ENCLOSURE 3
(NON-PROPRIETARY)

The attached document has been modified to reflect the use of Rosemount RTDs and is identified by the use of section, table and page numbers followed by the letter "b". A separate document reflecting the use of RdF RTDs has been written and is identified by the letter "a".

Questions:

Response: Rosemount RTDs

FIGURE 1
POWER CALORIMETRIC SCHEMATIC

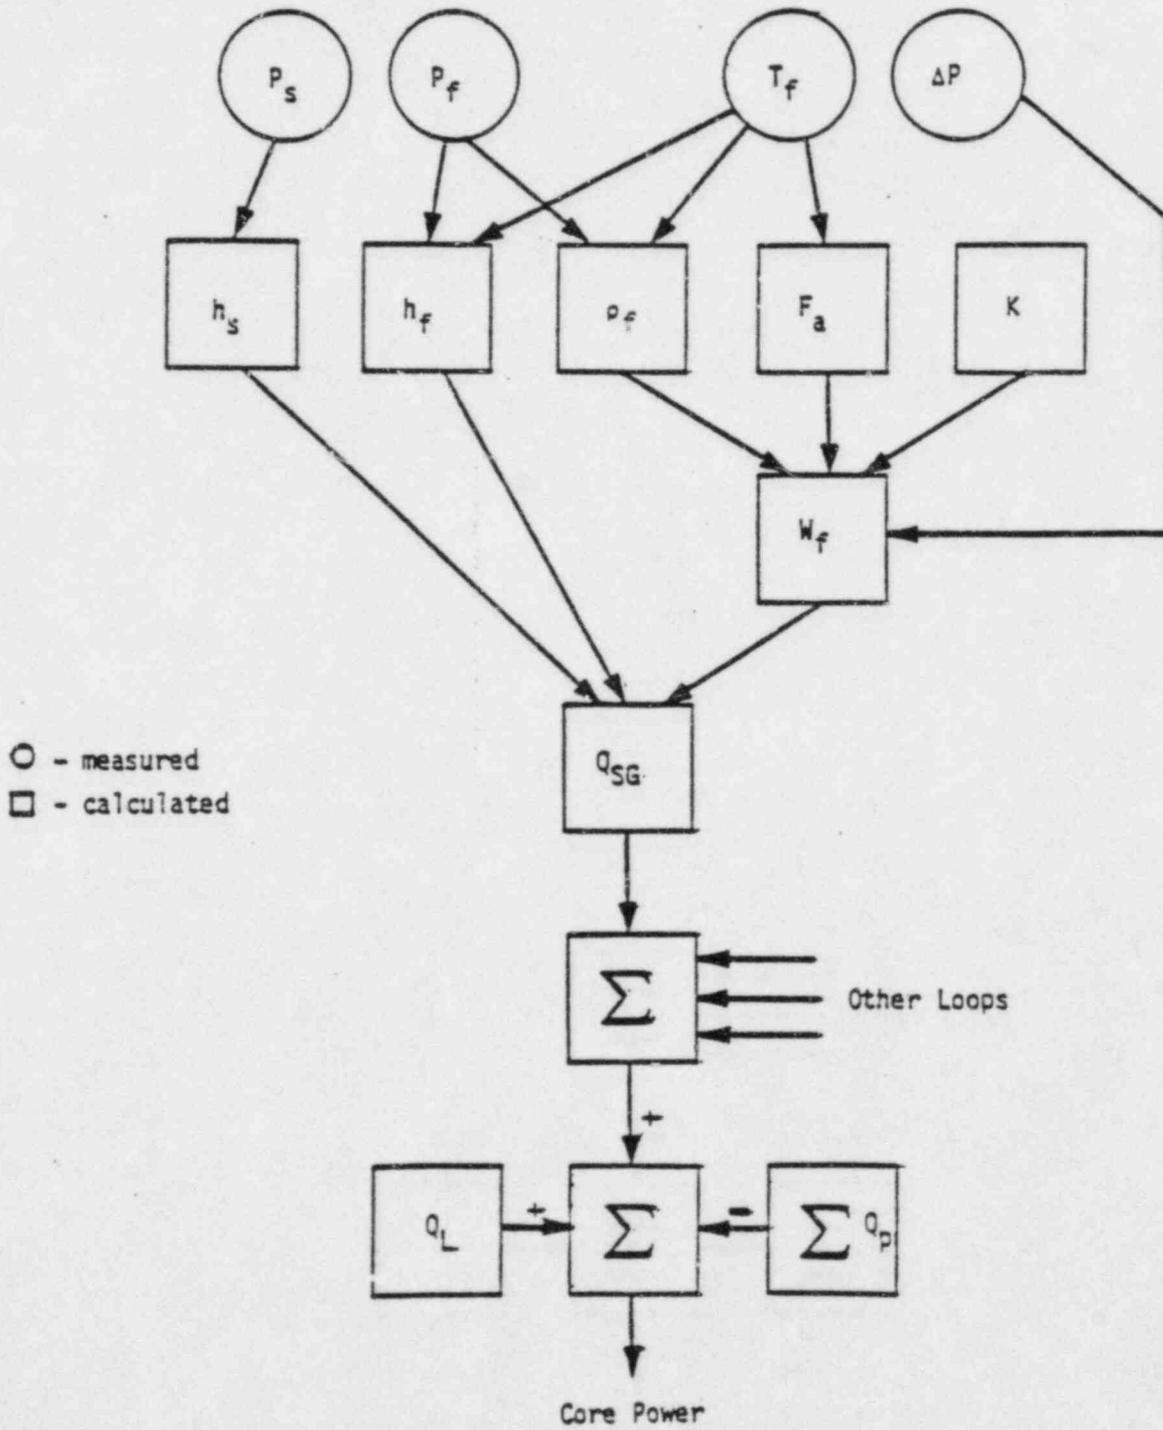
1. Provide and justify the variances and distributions for input parameters.
2. Justify that the nominal conditions used in the analyses bound all permitted modes of plant operation.
3. Provide a block diagram depicting sensor, processing equipment, computer, and readout devices for each parameter channel used in the uncertainty analysis. Within each element of the block diagram identify the accuracy, drift, range, span, operating limits, and setpoints. Identify the overall accuracy of each channel transmitter to final output and specify the minimum acceptable accuracy for use with the new procedure. Also identify the overall accuracy of the final output value and maximum accuracy requirements for each input channel for this final output device.

The core power measurement is based on the following plant measurements:

- Steamline pressure (P_s)
- Feedwater temperature (T_f)
- Feedwater pressure (P_f)
- Feedwater venturi differential pressure (Δp)
- Steam generator blowdown (if not secured)

These measurements and calculations are presented schematically on Figure 1.
